CERTIFICATE OF APPROPRIATENESS

Property: 3400 White Oak Dr, Lots 11 & 12, Block 279, Houston Heights Neighborhood Subdivision. The property includes a historic 9,640 square foot, two-story brick veneer commercial situated on a 13,198 square foot (132' x 100') corner lot.

Proposal: Alteration: Fenestration and Vehicle Openings

Existing Front (South) Elevation After Non-Historic Façade Removed

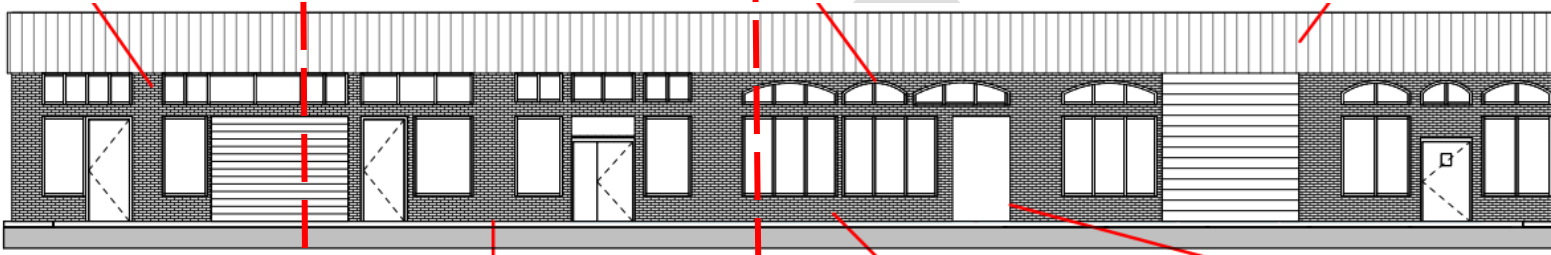
| <input type="checkbox"/> | <input checked="" type="checkbox"/> | <input type="checkbox"/> | (9) The proposed design for any exterior alterations or addition must not destroy significant historical, architectural, archaeological or cultural material, including but not limited to siding, windows, doors and porch elements; The wood studs, door and window framing, and cross beams are in repairable condition. |

These can be repaired and put back into its original locations. The complete removal of these studs and framing would destroy significant architectural materials.

- In accordance with Sec. 33-276, the proposed activity must comply with the City Council approved Design Guidelines. The removal of the studs, door and window framing, and cross beams that are evident on the front elevation does not preserve the historic building materials.

Proposed Front (South) Elevation (HAHC 11-9-2023)

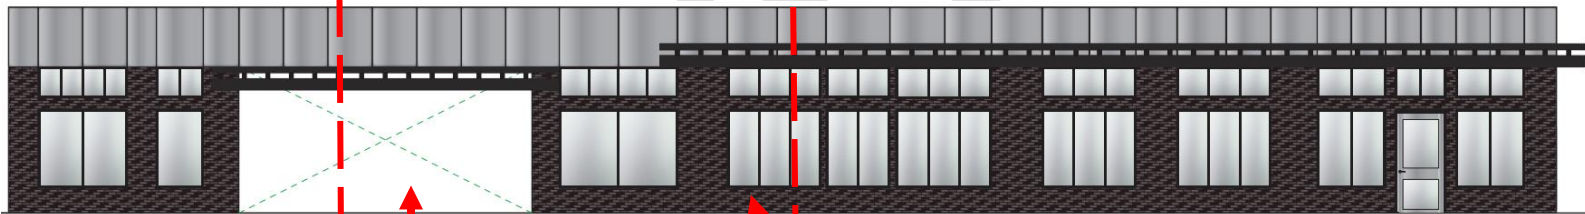
| <input type="checkbox"/> | <input checked="" type="checkbox"/> | <input type="checkbox"/> | (1) The proposed activity must retain and preserve the historical character of the property; The proposed front elevation does not preserve the historical character of the façade. A storefront is the most important architectural feature of historic commercial buildings. |
| <input type="checkbox"/> | <input checked="" type="checkbox"/> | <input type="checkbox"/> | (3) The proposed activity must recognize the building, structure, object or site as a product of its own time and avoid alterations that seek to create an earlier or later appearance; The proposed front elevation creates a later appearance. The existing openings (doors & windows) shows a distinguishing feature pattern of regularly spaced load-bearing brick columns, door openings, window openings, and window sashes, particularly on the right half of the façade where there exists semicircle sashes. |
| <input type="checkbox"/> | <input checked="" type="checkbox"/> | <input type="checkbox"/> | (4) The proposed activity must preserve the distinguishing qualities or character of the building, structure, object or site and its environment; The proposed front elevation removes the distinguishing fenestration configurations and does not preserve the storefront's distinguishing architectural feature. Storefront doors were often flanked by large, display windows. The removal of several door openings does not preserve the storefronts distinguishing quality and historical character. Transoms above the display windows became key elements in early 20th century storefronts. These transoms of the past could be opened to permit air circulation into the store. The proposed activity does not preserve the quality nor character of the building. |
| <input type="checkbox"/> | <input checked="" type="checkbox"/> | <input type="checkbox"/> | (5) The proposed activity must maintain or replicate distinctive stylistic exterior features or examples of skilled craftsmanship that characterize the building, structure, object or site; The proposed front elevation does not maintain nor does it replicate the distinctive fenestration configurations. The proposed front elevation eliminates a brick column and door/window opening for the widening of a vehicle bay. This elimination diminishes its historical character. |
| <input type="checkbox"/> | <input checked="" type="checkbox"/> | <input type="checkbox"/> | (7) The proposed replacement of exterior features, if any, should be based on an accurate duplication of features, substantiated by available historical, physical or pictorial evidence, where that evidence is available, rather than on conjectural designs or the availability of different architectural elements from other structures; The existing front elevation shows physical evidence of a distinctive fenestration pattern including semicircle window sashes on the right half of the elevation. The proposed front elevation does not accurately duplicate the existing fenestration openings as it removes several door openings, display windows, and transom windows along with a character-defining semicircle sashes in the transoms on the right half of the front elevation. |
